ADDENDUM NO. 1 FINAL CD DRAWINGS

Project: Johnson Brock Public Schools

Project No.: L13386

Date: January 31, 2014

E0.1a

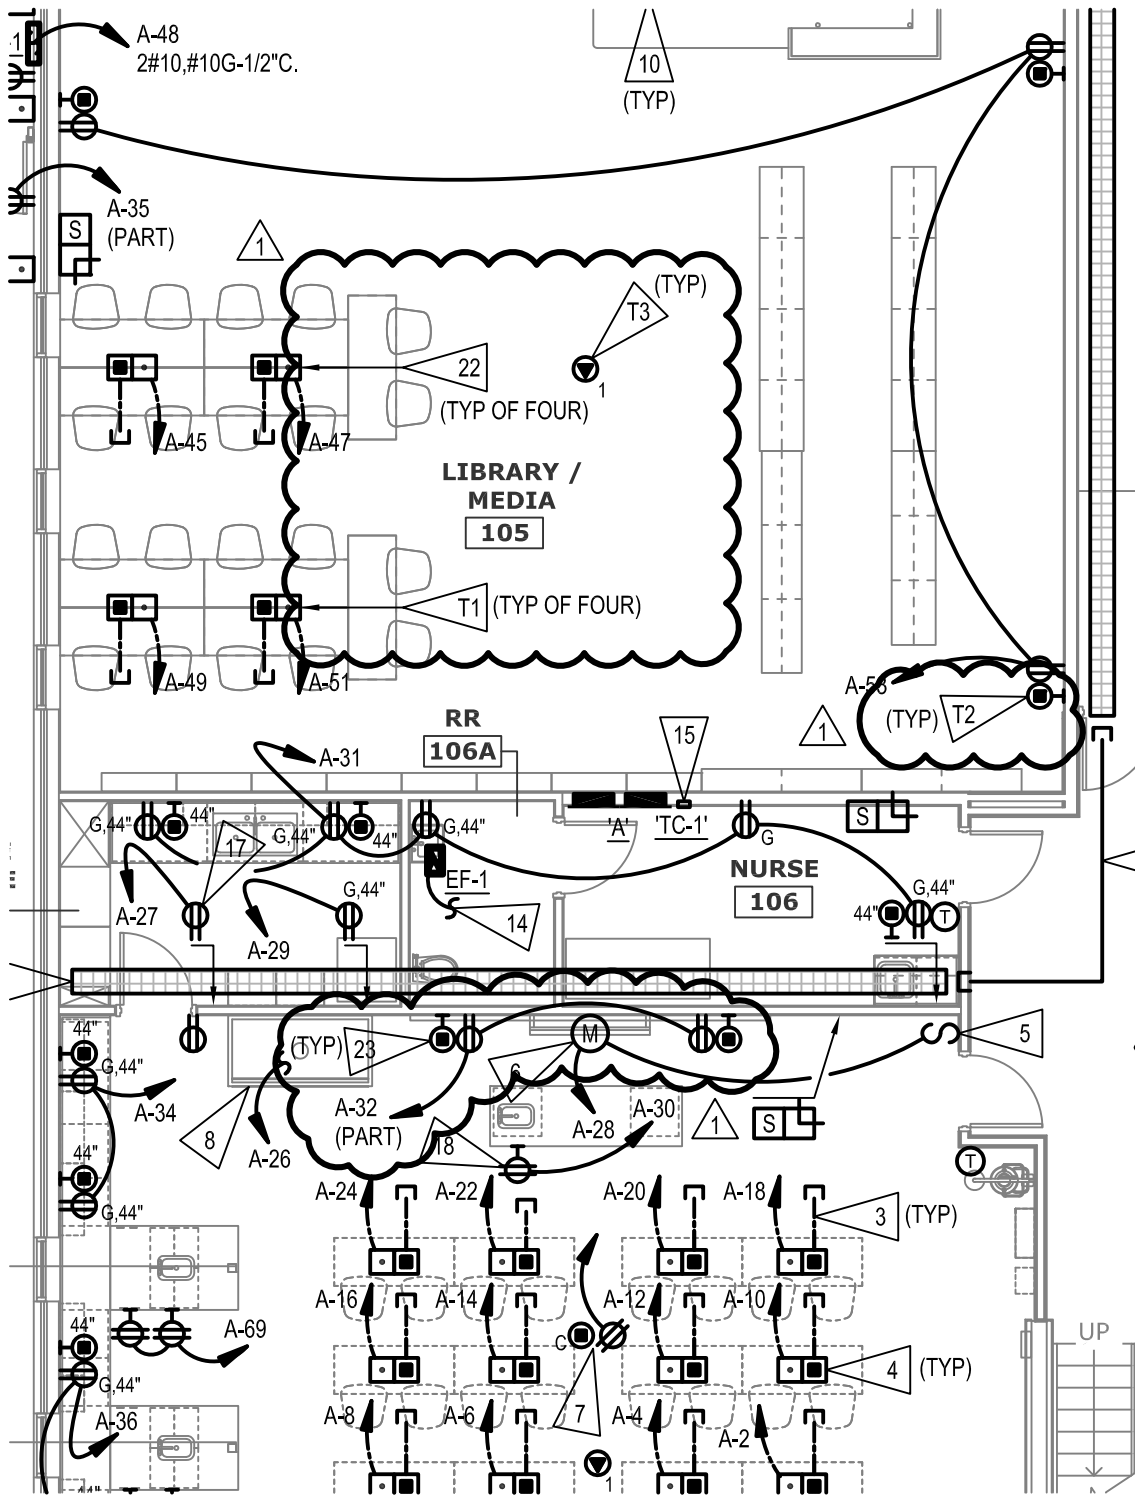
1. Additional fixtures and devices to be removed in demolition have been indicated in RR 112, for clarification. Reference sketch E0.1a.
2. Removal of existing conduits has been indicated. Reference sketch E0.1a.
3. Add to flag note 12: Locate combustion air fan in a position that will prohibit the freezing of any piping in the boiler room.

- 1
- 11 RECEPTACLE MOUNTED HIGH ON WALL.
 - 12 REMOVE PORTION OF EXISTING (2) 3" CONDUITS INDICATED HATCHED, FROM LOCATION INDICATED TO MECHANICAL ROOM PANEL LOCATED IN BASEMENT. FIELD COORDINATE PANEL LOCATION PRIOR TO DEMOLITION. PULL BACK EXISTING FEEDER CONDUCTORS AND PULL INTO NEW CONDUIT SERVING MECHANICAL ROOM. COORDINATE PANEL OUTAGE WITH OWNER PRIOR TO DEMOLITION. SEE SHEET E2.1 FOR ADDITIONAL INFORMATION. PATCH FLOOR PENETRATION TO MATCH EXISTING SURFACES.

sketch **E2.1a**

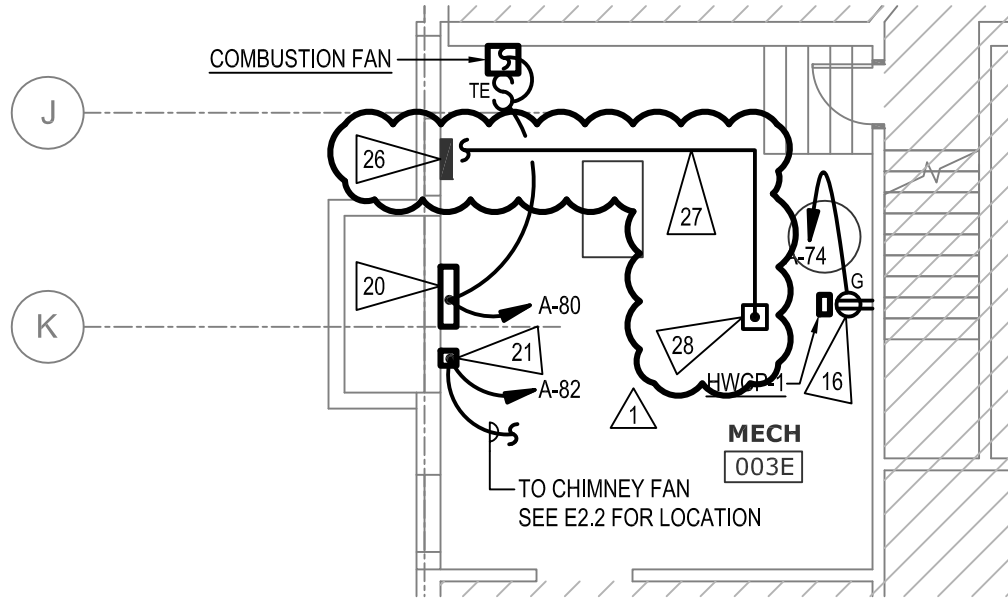
1. Clarified data requirements for floor boxes in Library/Media 105 and for all wall mounted data outlets and wireless access points in remodel. Reference sketch E2.1a.
2. Plans are now showing the intercepting and extending of conduits and feeders modified during demolition. Reference sketch E2.1b.
3. Flag notes and telecommunication specific flag notes have been added to clarify the changes listed in items a and b above. Reference sketch E2.1c.
